To: The Coordinator-General
EIS Project Manager – Underground Bus and Train Project
Office of the Coordinator-General
Department of State Development, Infrastructure and Planning

I am writing to you as part of the Environmental Impact Statement (EIS) process for the Underground Bus and Train (BaT) project. I have worked in railway and Public Transport planning for most of the last 10 year and have spent quite some time reviewing the EIS documentation available for the BaT project.

Review of the Underground Bus and Train (BaT) project EIS

Figure 3: Bus volume vs Road capacity in 2021

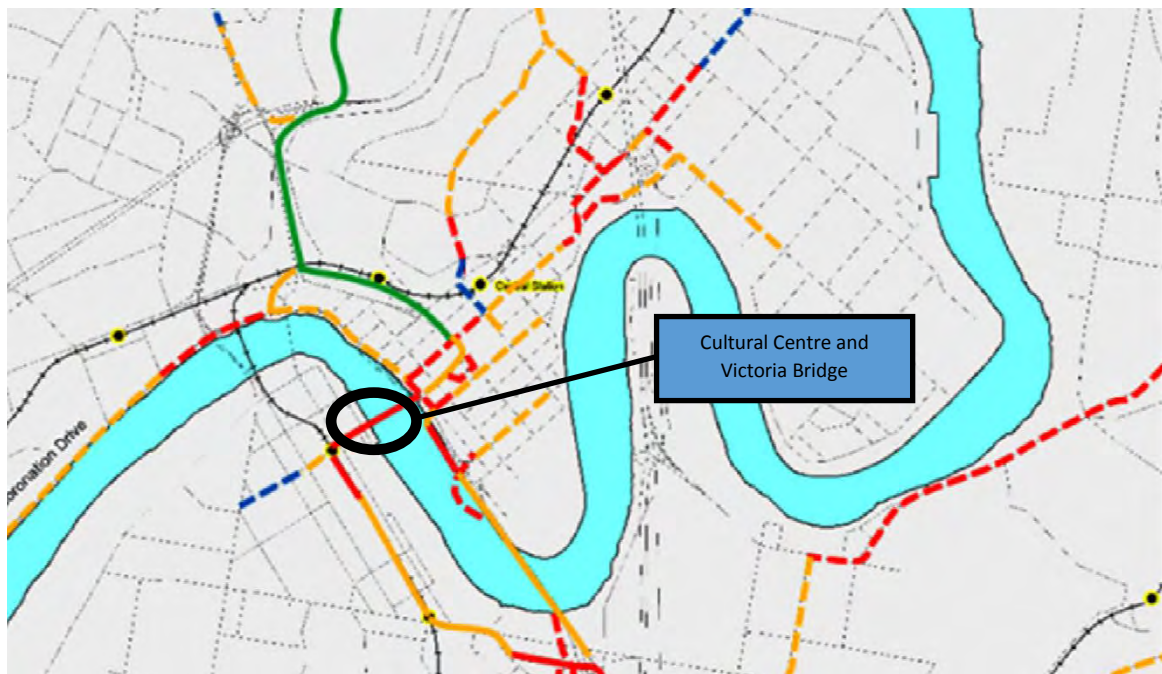
The volume of buses around the Cultural Centre and Victoria Bridge is well over the theoretical capacity of the road in this area. This is leading to lengthy delays on the Busway inbound in the morning peak and on the Victoria Bridge/North Quay area in the afternoon peak.

Looked at in isolation this congestion of buses would seem to support the need for additional infrastructure to alleviate the congestion in this area.

Indeed, the EIS attempts to lead you to this conclusion. However, this conclusion is wrong.

Figure 6: Model performance showing limit of modelling at Ormeau

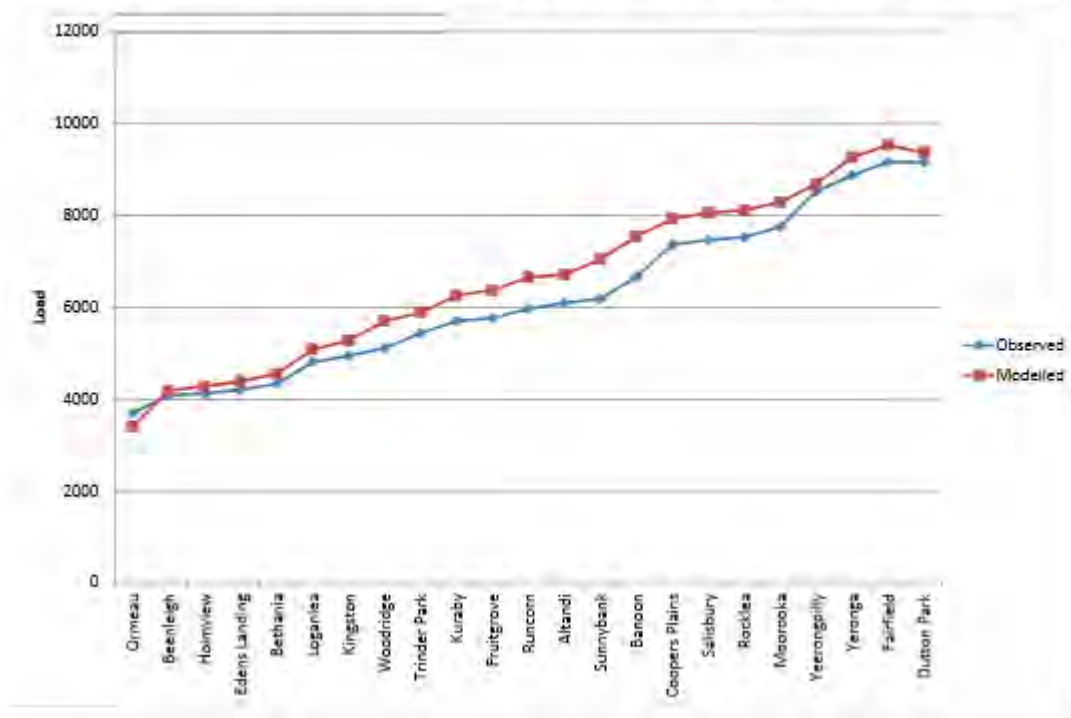
The Technical Transport Report, page 21, provides a diagram clearly showing that the modelling only extends as far south at Ormeau station – missing Coomera, Helensvale, Nerang, Robina and Varsity Lakes station. This diagram is shown below in Figure 6.

There are no forecasts of the boardings, alightings or demand growth from the Gold Coast stations included in the EIS.

The lack of such forecasts is inexcusable as the crowding on the Gold Coast services was a key reason that additional inner-city capacity is required.
